**DEPARTMENT OF DEVELOPMENT SERVICES – PLANNING DIVISION**  
REPORT: Site Plan for a Food Truck Park at 510 Farmington Avenue for consideration on Tuesday February 22, 2022

**STAFF REPORT**

**PROJECT:** Site Plan for a Food Truck Park  
510 Farmington Avenue  
**PARCEL ID:** 133-310-072  
**ENERGOV ID:** ADMIN-2021-2670

**TYPE:** Site plan application for a food truck park, pursuant to Section 1.3.C.(1) and Section 3.7.3 of the Zoning Regulations.

Figure 2. Proposed site plan, submitted by Rebeca Quach, dated February 15, 2022.

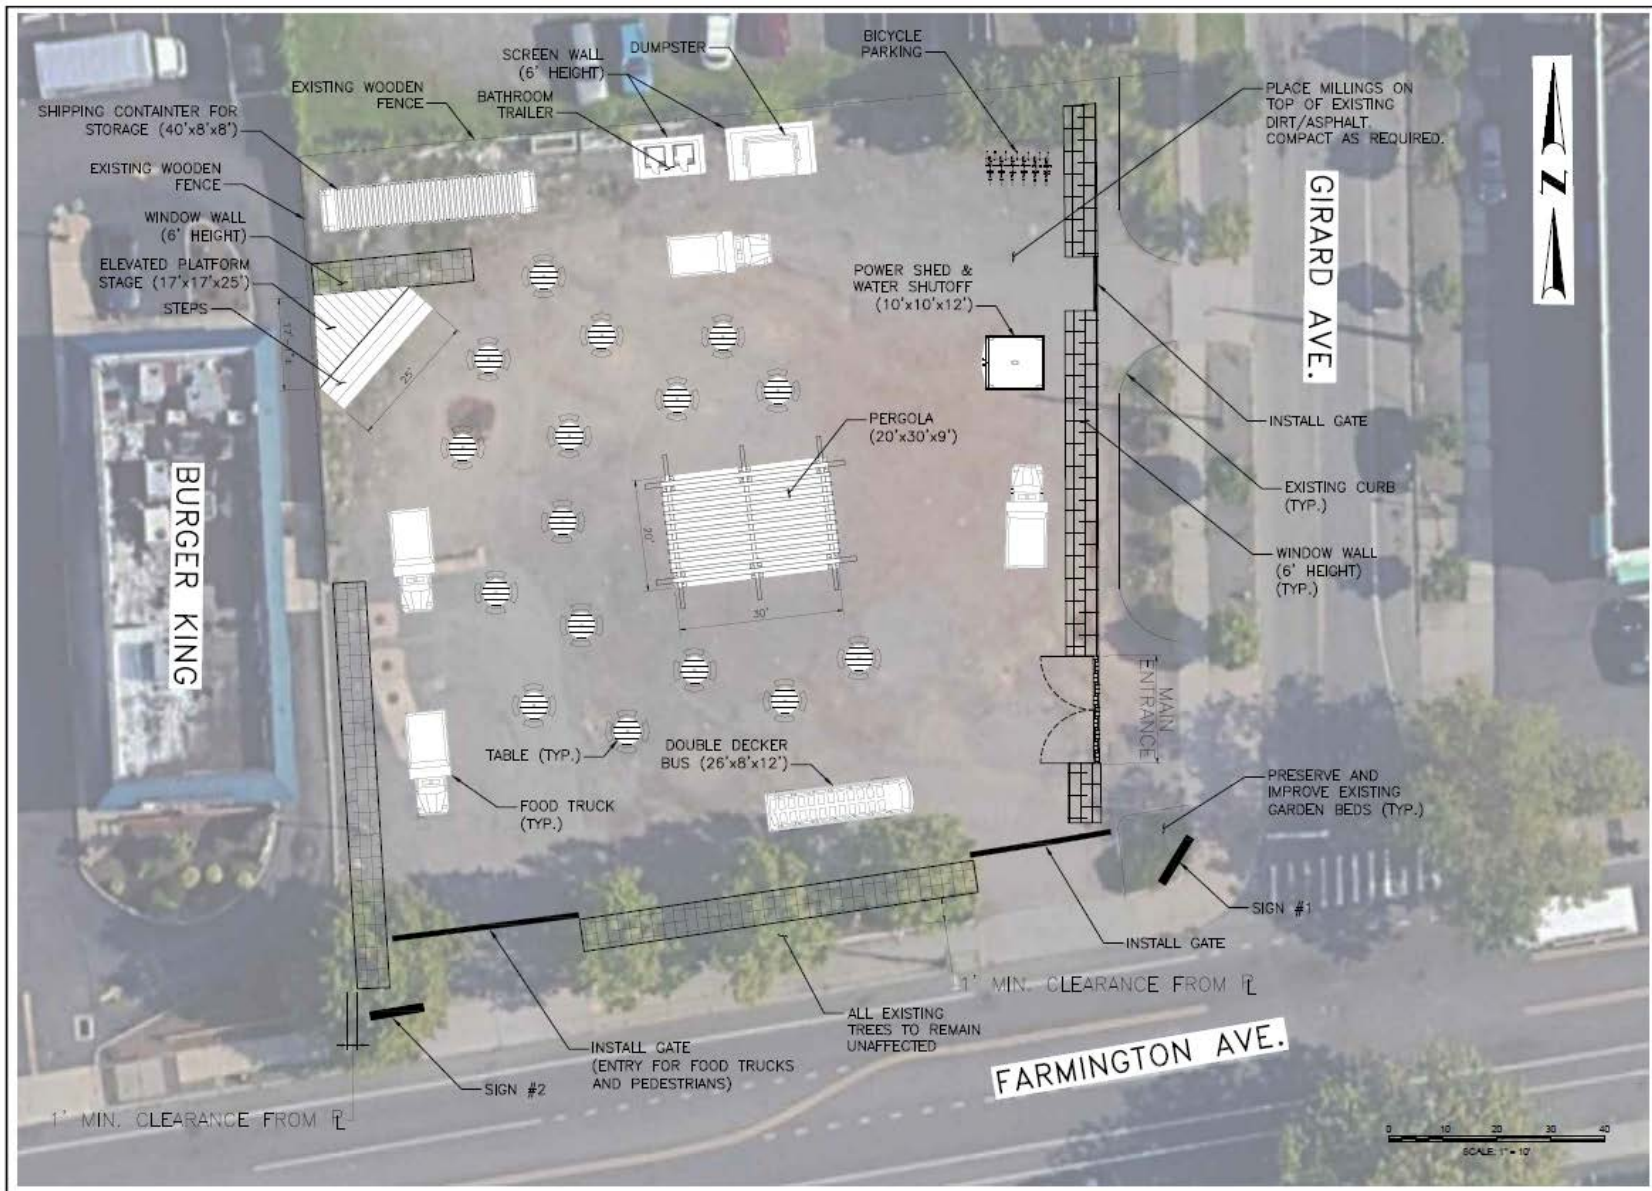
permitted per lot. It must be limited in size to either 825 cubic sf or an area of 180 sf. The proposed container measures 40 ft x 8 ft x 8 ft (2,560 cubic ft), which exceeds the allowable size. While staff recommends flexibility regarding the size of the storage container given the lack of primary structure on-site, the storage container cannot serve as the primary structure. Staff also recommends that the applicant update the site plan to include a 5-foot side and rear setback. Note that a temporary use permit for a storage container at this property, approved September 13, 2021 (ADMIN-2021-2376) will be voided if this site plan application is approved.

Stages and bathroom trailers are not listed accessory structures in the Regulations. However, the general 5-foot side and rear setback requirements (Section 4.20.2.B) should be applied to both. Staff recommends that the applicant update the site plan accordingly.

The applicant is preserving the existing garden beds on Farmington Avenue and Girard Avenue, and no tree removal is proposed. The applicant has stated they will make improvements to the garden beds along Girard Avenue, but no landscaping plan or schedule has been submitted for review. Staff recommends that the applicant submit a landscaping plan or schedule for review.

The proposed dumpster is located in the rear yard, which is permitted by the Regulations. The dumpster will be properly screened on three sides with a 6-foot high opaque wall. However, because the dumpster will likely be visible from Farmington Avenue and by patrons of the food truck park, staff recommends that the applicant also add an opaque gate on the front portion of the dumpster, as required in Section 6.12.2.A.

not advised the applicant to permanently close any of the curbcuts due to the temporary nature do the use. Staff recommend that the applicant revise the site plan to locate large planters or temporary bollards in any open gate in a manner that does not obstruct the right-of-way and is approved by the Fire Marshall.

On the one hand, staff agrees generally with limiting fence height to no more than 4 or 4.5 feet in front and corner side yards to avoid setting a precedent for waiving this requirement. Staff would recommend that future text amendments associated with this (or a similar) use clearly address this issue. On the other hand, given the lack of a primary building and the need to safeguard the many accessory structures that will stay on-site overnight, it is understandable that the applicant wishes to secure the site with a taller fence. Furthermore, the wall will have a relatively high amount of transparency given the use of glass, which helps mitigate the lack of transparency caused by the height of the fence. From an urban design standpoint, the taller fence with the added transparency would help to create a continuous street wall and provide sufficient design to engage passersby. In addition, the window wall could be considered a façade and not a fence given that it is made of building façade materials and given that it is proposed to be placed in the build-to-zone. Overall, staff recommends that the applicant be allowed to install the 6-foot high window wall, if there is a way for the Commission to justify the deviation from the Regulations.

The site plan currently includes a wave-type bicycle rack that can fit up to six bicycles. Staff recommends that the applicant change the type of bicycle rack to inverted-U or bollard-type racks instead per Section 7.3.3.C. The specific number of bicycle spaces required by the Regulations is unclear, since this also depends on the principal use. Bicycle parking requirements apply for the establishment of a new use, but not for temporary open-air uses such as farmers' markets or bazaars (see Section 7.2.2.C). However, the food truck park differs from farmer's markets in that it will be open several days a week, for an extended period of time. Staff recommends that the retail & service use bicycle parking requirement be used as a benchmark (1 space per every 3,000 square feet), and therefore recommends that the bike parking on-site accommodate at least six bicycles.

- However, the signs do not comply with the placement requirement. The Regulations state that the signs should be located 10 feet from driveways and side property lines and 3 feet from property lines. Both proposed signs are located near a driveway and are not 3 feet away from the property line.

Staff recommends denial of the monument signs. The applicant can likely find a way to meet the placement requirements (3 feet from property line and 10 feet from active driveways), but the additional modification to the Regulations would be needed to account for signage not associated with the specific named building types. Alternatively, staff recommend that the Applicant consider installing the signs as wall signs on the window wall instead.

3. The Applicant shall make the following edits to the site plan prior to final plan approval:
  - a. The storage container, stage, and bathroom trailers shall be moved to have a 5-foot side and rear setback.

- b. A landscaping plan or schedule shall be submitted for review by staff.
  - c. An opaque gate shall be added on the front portion of the dumpster enclosure.

- d. Large planters or temporary bollards shall be located in any open gate in a manner that does not obstruct the right-of-way and is approved by the Fire Marshall.

- e. The bicycle racks shall be changed to to inverted-U or bollard types, and at least three racks (which can park 2 bicycle each) shall be provided.

- f. The signage shall be installed as wall signs on the window wall.
4. The temporary permit for a storage container approved on September 13, 2021 (ADMIN-2021-2376) shall be voided.
